Development Application **ACCESS REPORT**

Reference Number: 23213

Client: IMG Group

Site Address: Federal Hotel, Mudgee

[Image description: Plan of the ground floor above shows the provision of Accessible parking spaces]

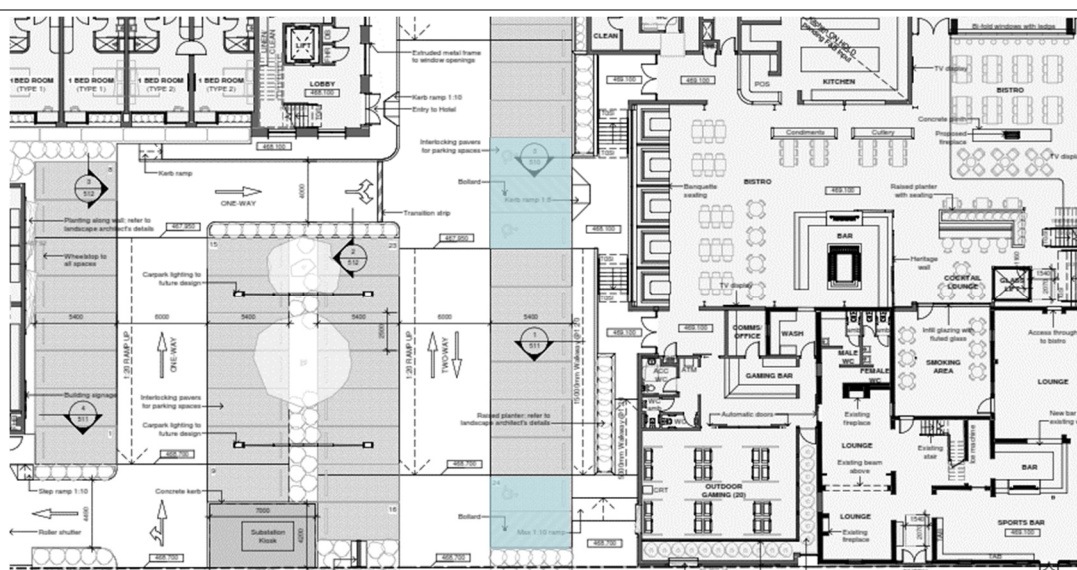
Total number of carparking spaces provided = 8

Total number of accessible parking spaces required as per the formula listed above in the requirements = 1, however 2 have been provided.

Total number of Accessible parking spaces required for the commercial component of the development = 1
